Addendum 74 – UN Regulation No. 75

Revision 2 - Amendment 6

Supplement 19 to the original version of the Regulation – Date of entry into force:
30 September 2021

Uniform provisions concerning the approval of pneumatic tyres for L-category vehicles

Annex 2, amend to read:

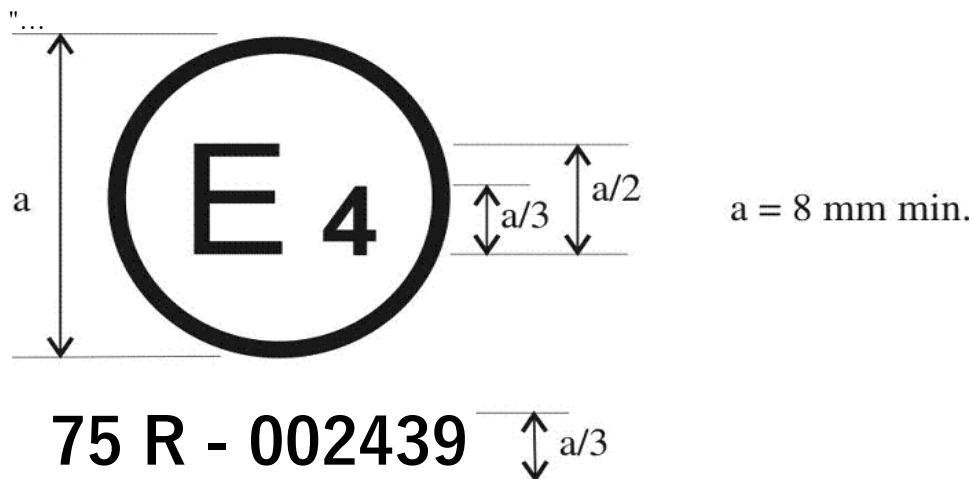
The above approval mark affixed to a tyre shows that the type of tyre concerned has been approved in the Netherlands (E 4) pursuant to UN Regulation No. 75 under approval number 002439. The first two digits of the approval number indicate that the approval was granted in accordance with the requirements of UN Regulation No. 75 in its original form.
